GROUP Brake System	MODEL 2011MY Sorento (XM)
	NUMBER PS252	DATE May 2013

<p>SUBJECT: 2011MY SORENTO STOP LAMP SWITCH INOPERATIVE AFTER PERFORMING CAMPAIGN SC098</p>

P/N 93810 3K300QK
Only applies to 2006-07 Sorento (BL)
Do not use in any other application

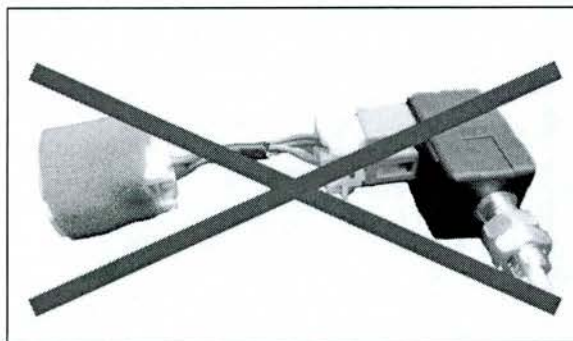
This article provides information regarding a small number of nonfunctioning stop lamp switches in Sorento (XM) vehicles, after performing Voluntary Safety Recall Campaign SC098. It is possible that in some cases, as a result of a previous improper repair, an incorrect stop lamp switch, originally supplied only for 2006-07MY Sorento (BL) vehicles, was installed in 2011MY Sorento vehicles. The stop lamp switch in question has a pigtail (see image) and installation of this pigtail into the new solid state switch results in a reversal of polarity at the switch. Polarity is critical for the correct operation of the new switch and, therefore, it will not function as intended if the pigtail is used.

If you encounter a situation as described above, remove the switch and pigtail from the vehicle's wiring harness and discard them. Plug the vehicle's wiring harness directly into the new stop lamp switch as described in Voluntary Safety Recall Campaign SC098. Once installation is complete, verify proper operation of the stop lamps.
